Government of the Northwest Territories
Technical Report for the
Dominion Diamond Ekati Corporation
Jay Project
EA1314-01

Mackenzie Valley Environmental Impact Review Board

July 31, 2015

Figure 1: Updated Assessment Case vs. Reasonable Estimate Case (DDEC, 2015b (Presentation – Modeling Workshop, July 6, 2015))

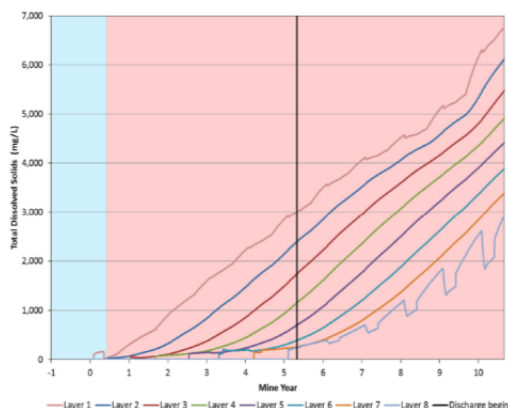
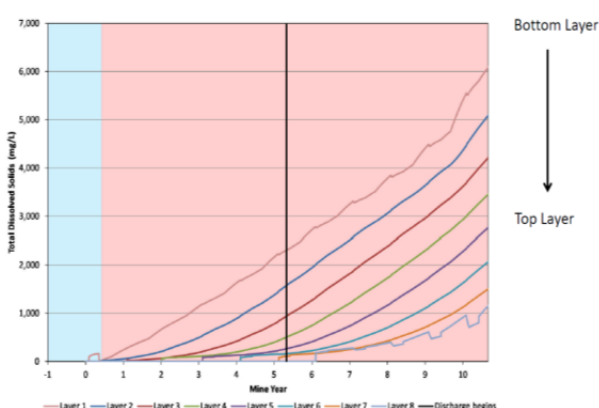
The figures above show that over time concentrations of TDS in Misery Pit increase. This is consistent with the predicted concentration of TDS in the mine water inflow. The GNWT notes that the proportion of connate groundwater reporting to the Jay Pit increases as the depth of the pit increases. It is the connate groundwater that has the high TDS concentrations. The GNWT further notes that it is during the later years of the Jay Pit development, when the pit is at its greatest depth, that the worst quality water will accumulate.

However, during early years of mining, water from within Jay Pit that reports to the Misery Pit is generally predicted to be of better quality. This is likely due to a higher ratio of surface water reporting to the Jay Pit than connate water early in the mine life. As shown in Figure 2, concentrations of TDS gradually increase in Misery Pit with time, for example under the Reasonable Estimate Case TDS approaches 500 mg/L in Year 9. For the lower bound case, the increase in TDS is lessened and delayed. This is likely due to lower volumes of inflows as well as lower concentrations of TDS over time. It is Year 9 and Year 10 when inflows have the highest TDS concentrations (i.e. DAR Submission/Updated Assessment Case and Reasonable Estimate Case). These peaks correspond to the levels that contribute to concerns associated with toxicity, as described above. As such, the GNWT is of the opinion that a strategy whereby discharge is curtailed in Year 9 and Year 10 would help allay toxicity concerns at the discharge location in Lac du Sauvage. To accommodate this, Misery Pit would require drawdown sooner than Year 5 (2023) to increase storage in later years.

Commencing effluent discharge sooner in the mine life would increase storage potential for mine water from Jay Pit. For example, starting effluent discharge in the summer of Year 3 would provide additional storage volume later, in Year 9 and in Year 10. Effluent quality in Year 3 would also be better than Year 9 and Year 10, i.e. generally it should be much less than 500 mg/L TDS (see Figure 1). The GNWT notes that summer mixing seems to be more effective than in winter (Table 1). Starting effluent discharge in Year 3 would also provide a few years for the meromictic condition to establish in Misery Pit during active operations, as illustrated in Figure 1 above. The lower discharge concentrations and reduced volumes of discharge would reduce loadings to Lac du Sauvage. Discharge volumes would be lower in early years as the inflow rates would be less into Jay Pit early in the development. These inflow rates increase with time (as would the discharge volume) as the depth of the Jay Pit increases.

Figure 3: Mixolimnion and Monimolimnion Analyte Ratios for Conductivity (Zajdlík and Associates Inc, 2015)

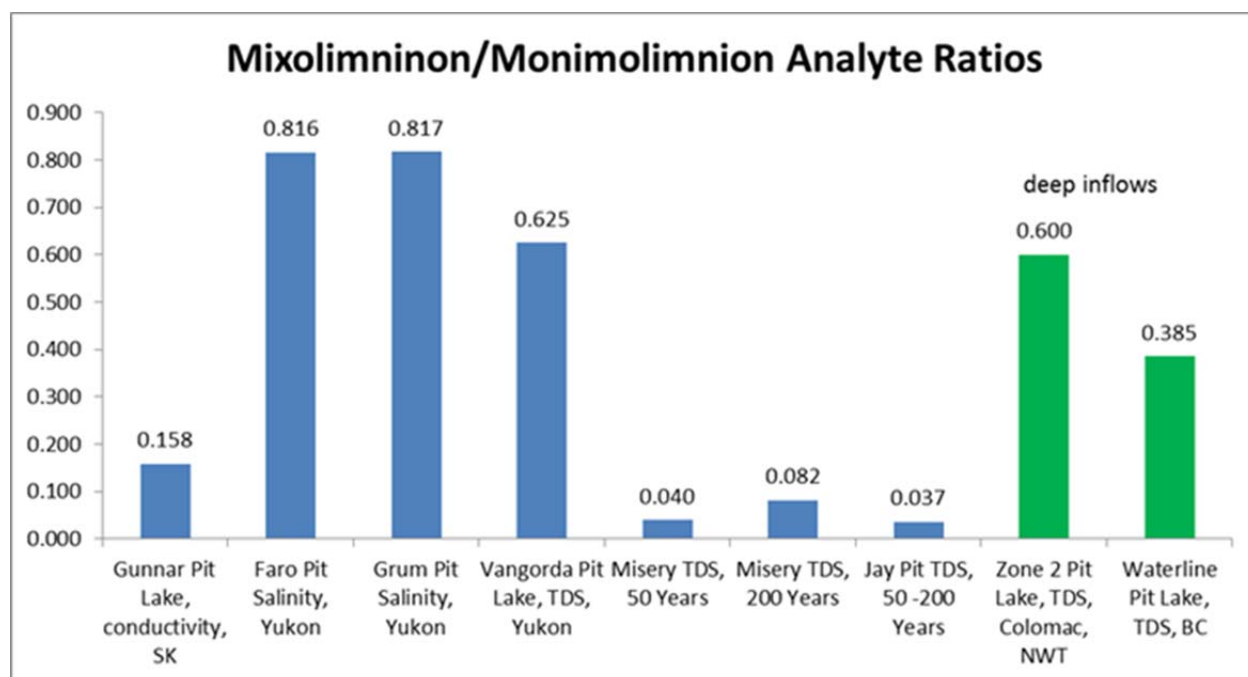
However, there remains some uncertainty as to the degree of difference that will evolve between the upper layer of the pit lake (mixolimnion) and the bottom layer of the pit lake (monimolimnion). The ratio of difference between these layers in the literature that DDEC presented as supporting evidence is an order of magnitude higher than the ratios that are proposed for the upper and lower layers in the Jay and Misery Pit Lakes (DDEC response to DAR-GNWT-IR2-08). For example, some of these pit lakes referenced by DDEC suggest as little as 200 mg/L difference between concentrations in the mixolimnion and monimolimnion (Faro Mine Yukon - Faro Pit Salinity 1250 mg/L monimolimnion and 1020 mg/L mixolimnion; Grum Pit Salinity 900 mg/L monimolimnion and 735 mg/L mixolimnion (Pieters and Lawrence, 2014)). Other ratios are expressed in Figure 3 below.

DDEC predicts drastic differences in salinity gradients between the upper and lower layers within Misery and Jay Pit Lake and GNWT is concerned that these differences may not persist in the Misery and Jay Pits. DDEC has relied upon modeling of the pit lakes in making these predictions. The GNWT would like to acknowledge DDEC and its consultants for the numerous meetings and teleconferences to discuss the issues and answer questions about the modeling. Meeting records have been submitted to MVEIRB and are posted to the registry. However, some outstanding concerns remain in this regard as there may be a few drivers that make the Misery and Jay Pit Lake unique, most notably the depth of the pits, their fetch and the initial salinity differences in the layers.

Figure 4: Predicted Water Quality at the Surface and at Depth in Misery and Jay Pit Lakes Post Closure (DDEC, 2015b - Presentation – Modeling Workshop, July 6, 2015)

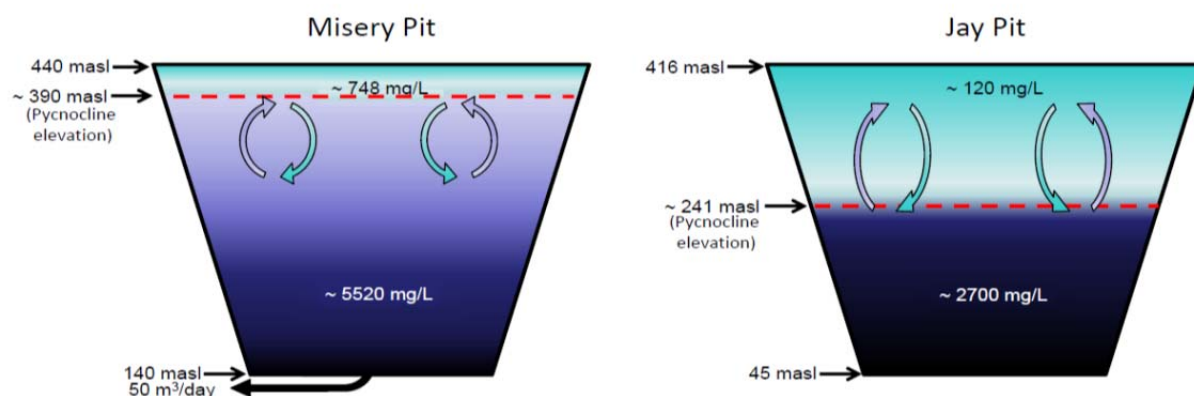
The GNWT has expressed concern with water quality within the fresh water cap in the Misery Pit Lake over time. Figure 4 below illustrates the predicted quality of the surface layer in the Misery and Jay Pit over time (i.e. 200+ years). The GNWT concludes that surface water quality within the upper layer of the Misery Pit Lake at ~748 mg/L TDS would not be an acceptable closure strategy for the pit, as these concentrations are not consistent with naturally occurring conditions in the local ecosystem nor do they align with the current closure conditions approved in the Ekati ICRP. The GNWT notes that under the current approved ICRP, for Misery Pit, fresh water is to be pumped from Lac de Gras to completely fill the pit and create a self-sustaining ecosystem. This would result in water quality within Misery Pit Lake of similar quality as Lac de Gras, orders of magnitude better than that proposed for Misery under the Jay Project.

Upon questioning about the long term water quality in the surface layer of the Misery Pit Lake, DDEC indicated that it was conceivable that water quality within the fresh water cap post closure would improve if the depth of the fresh water cap was increased (DDEC, 2015c, response to the GNWT's IR2-6). The GNWT assumes that this means the depth of the water cap was increased to be greater than 60 m, as the current assessment case for the Misery Pit Lake is a 60 m fresh water cap. Further, DDEC agreed to monitor water quality within the pit during operations and modify the depth of the water cap to satisfy existing closure goals and objectives.

The GNWT is pleased that DDEC is willing to look at options during operations but would like better assurances that they would create a deeper fresh water cap in Misery Pit at closure if conditions are expected to be similar to that described by the current water quality modeling within the fresh water cap (i.e. > 500 mg/L TDS). The GNWT
